RESPONSE TO REQUEST FOR ADDITIONAL INFORMATION

APR1400 Design Certification

Docket No. 52-046

RAI No.: 237-8312
SRP Section: 03.06.03 – Leak-Before-Break Evaluation Procedures
Application Section: 3.6.3
Date of RAI Issue: 10/08/2015

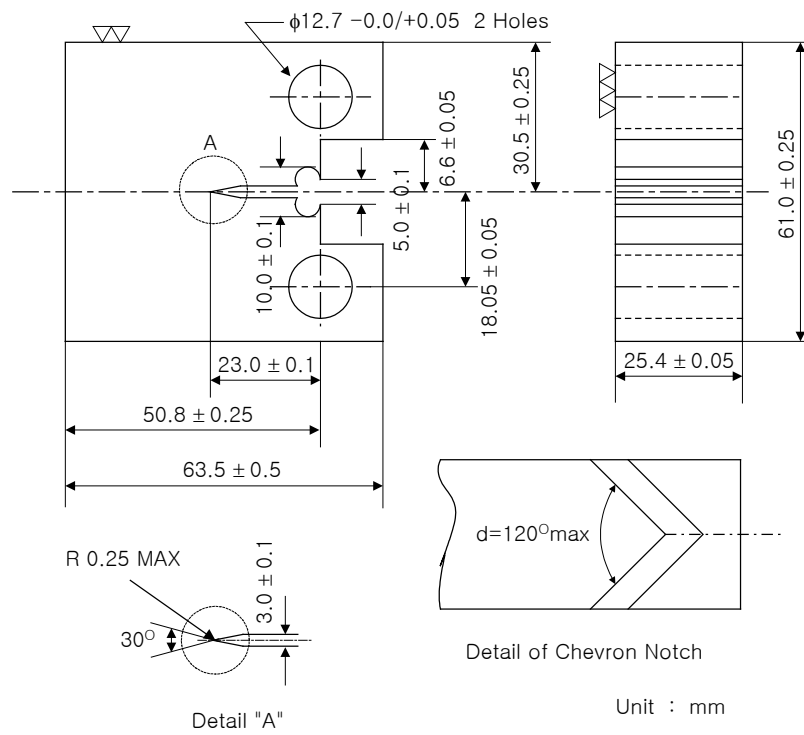
1. The NRC staff finds that it is appropriate to include the initiation fracture toughness, J_{ic} , in the calculation of crack opening displacement. Please re-evaluate J-R data to derive a description which includes J_{ic} .
2. In order to enable the NRC staff to evaluate the J-R data, the specimen size (including specimen geometry and notch depth) must be given. Please provide this data along with tabular J-delta (a) data.

2. The specific specimen geometry of the J-R test is provided as follows:

- 1) Specimen configuration: ASTM standard specimen for fracture toughness test of 1T-CT. Refer to the figure below for the detailed dimensions of the specimen
- 2) Specimen orientation: L-C orientation
- 3) Initial crack length: approximately 50% of the width of the specimen
- 4) Fatigue pre-crack is applied
- 5) Side-groove of 10% of the specimen width on both sides of the specimen
- 6) Test method: ASTM E1820
